Re: Water Treatment Plant – Construction Contingency Expense No. 4

Proposal No. 017 (RFP 012): Filter Slab Modifications:

Request For Proposal No. 012

Re: Filter Slab Modifications

DRAWING
S203

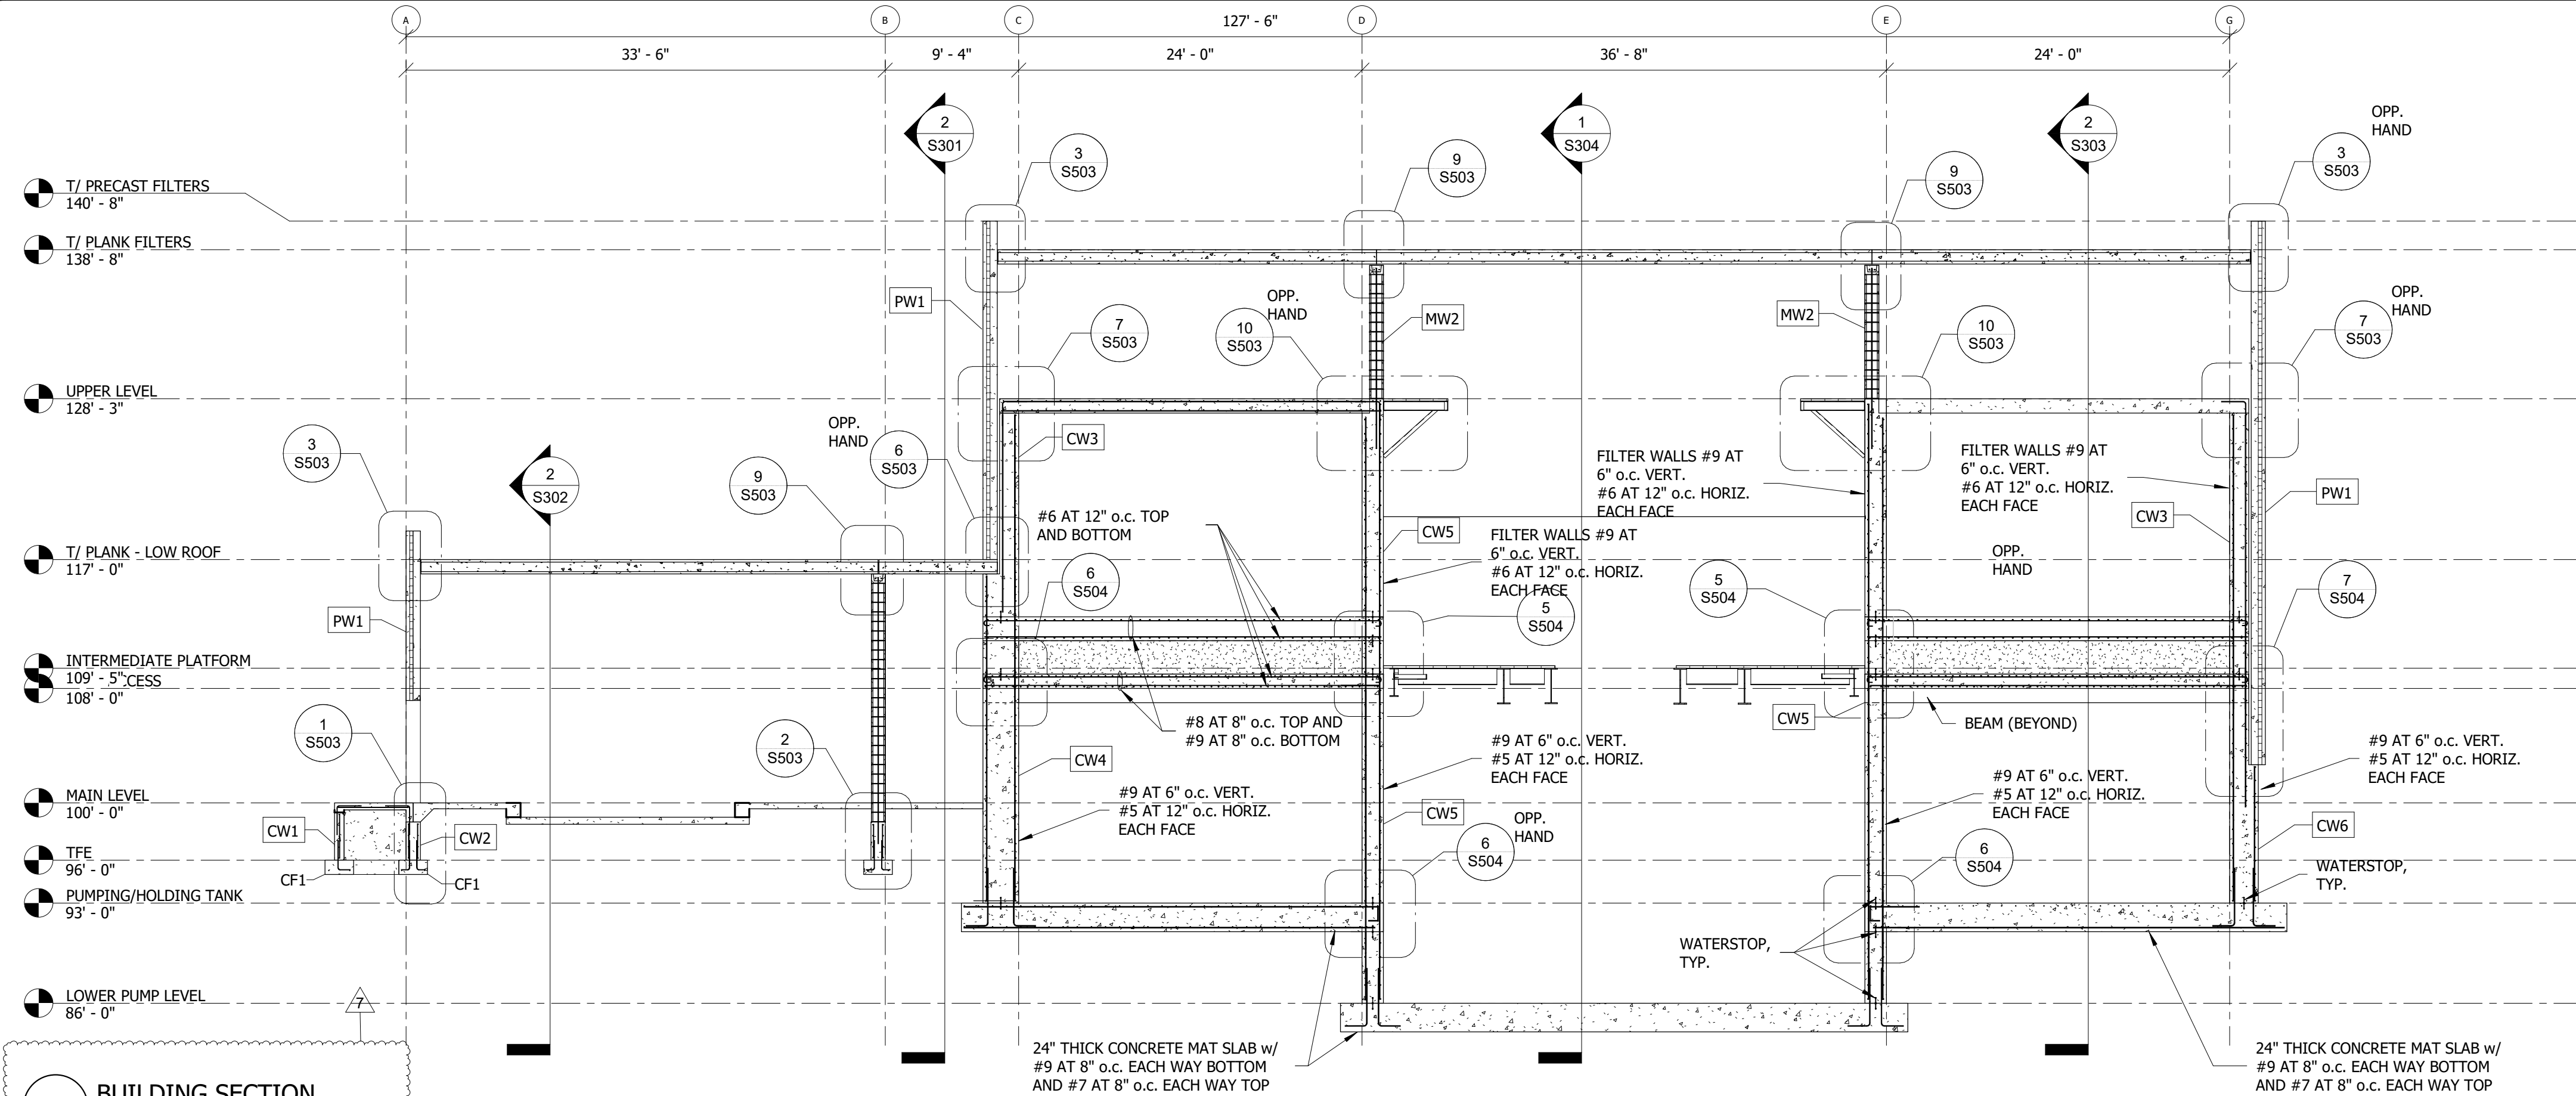
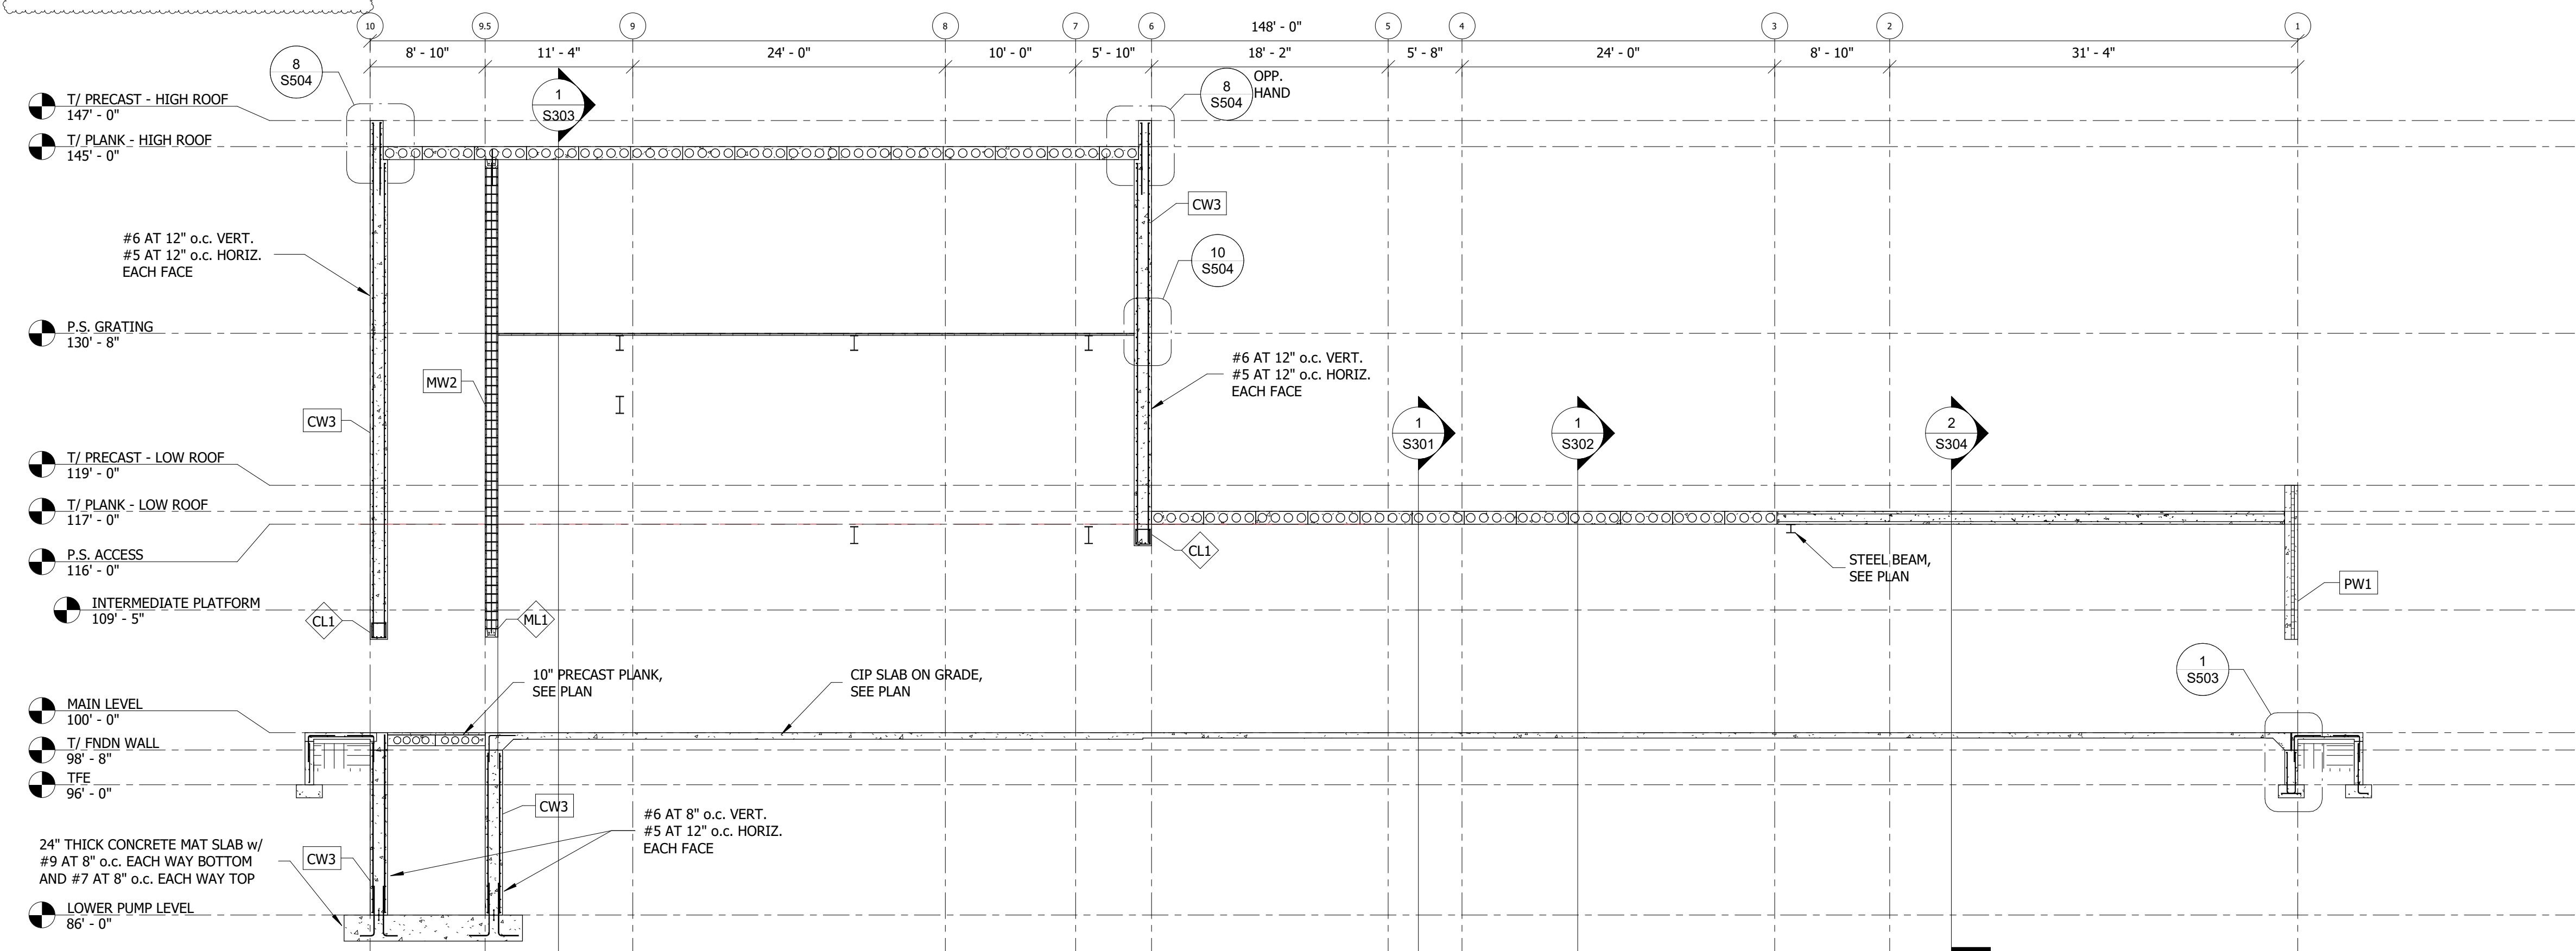
AE2S requests pricing from Magney for changes to the filter slab and CIP supports beams in the clearwell and backwash reclaim tank. Changes include but are not limited to extending the filter slab at elevation 113', increasing the slab thickness to 20" and increasing the CIP beams in the clearwell and backwash tank from 24" to 52". We also request pricing for raising the height of the gullet wall and filter trough to 121'-11". See attached drawings for any additional changes required. Once approved, Contractor will need to resubmit submittal 135 – Concrete reinforcement WTP structural slab, based on provided drawings. See sheets S203, S301, S302, S303, S305, S504, S505 and S601 attached.

Ryan,
Magney Construction, Inc. is pleased to present the following quotation to furnish the necessary labor, material, and equipment to complete the requested changes in RFP 012 - Filter Slab Modifications. To extend and thicken the slab at 113' with required rebar modifications, increase the Clearwell and Backwash beam heights to 52". Along with raising the gullet walls to 121'11". The costs associated with change are summarized below.
